Docket Item # 16
BAR CASE # 2008-0104

BAR Meeting
July 9, 2008

ISSUE: Alterations
APPLICANT: Maureen Dugan
LOCATION: 819 Green Street
ZONE: RM/Townhouse Zone

Figure 3. Proposed picket fence for front yard.

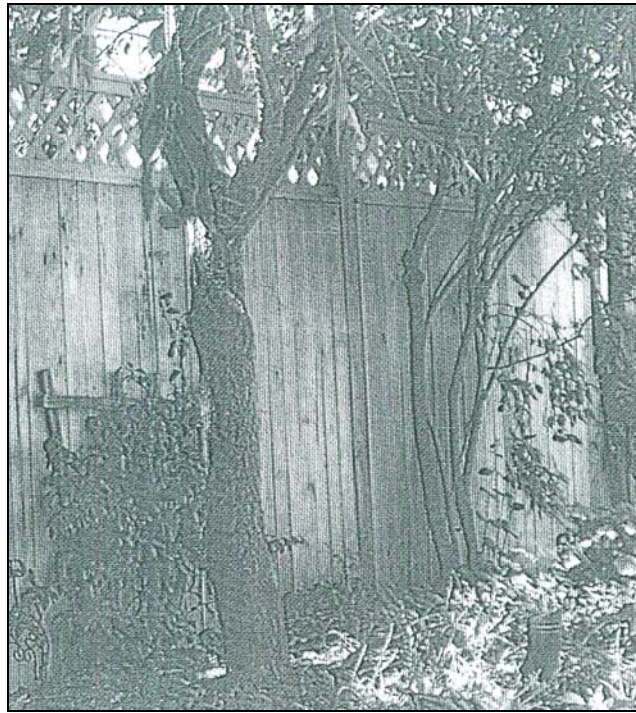
Regarding the gates, Staff finds a modest arch to be compatible for the front picket fence but recommends a flat-top gate for the rear yard fence.

C-1 The proposed front fence must be constructed on the subject lot and not encroach upon the public right-of-way. The submitted fence proposal and survey plat show the proposed fence to be encroaching 7 feet into the Green Street public right-of-way.

Figure 4. Proposed board and lattice fence for rear yard.

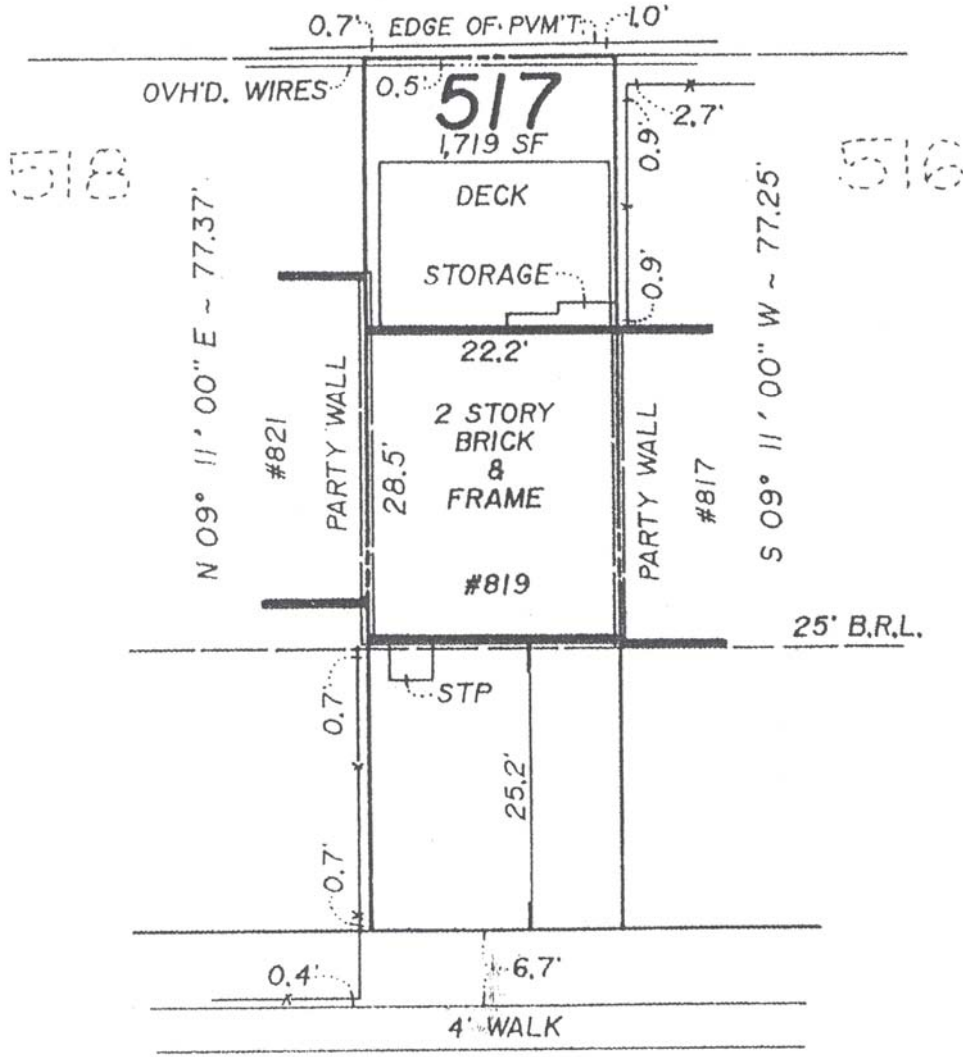
The *Design Guidelines* state that "fences, garden walls and gates should be appropriate in materials, design and scale to the period and character of the structure they surround." For lattice fences, the Guidelines state that "modern, mass-produced wood diagonal lattice is also not appropriate in the historic districts" and that "wood lattice should have a rectangular pattern." The proposed fences will both be wood and are materially compatible to the existing townhouse. The applicant is proposing lattice work with a diagonal pattern, which conflicts with the *Design Guidelines*. Staff recommends that the applicant revise the design to be rectangular lattice.

The Zoning Ordinance does not permit fences to be more than 6' in height. However, the height requirement may be waived or modified by the Board where the Board finds a proposed fence to be architecturally appropriate and consistent with the character of the district. The fences on the alley elevation range from 5' to more than 8'. An apartment building is located on the opposite side of the alley and has no fence. While the Board may waive the height requirement if it is architecturally appropriate and consistent with the character of the district, Staff finds that 8' is not compatible. However, Staff finds acceptable a 7' fence that is 6' of solid board with an additional 1' permitted for the lattice. This type of configuration is compatible with the range of fence heights and permits a sense of transparency for the portion of the fence above 6'.

1. That the proposed fence be 7' in height (6' of solid board fencing with 1' of lattice on the top);
2. That the lattice be horizontal instead of diagonal in form;
3. That the wood be either painted or stained; and
4. That the rear gate have a flat top.
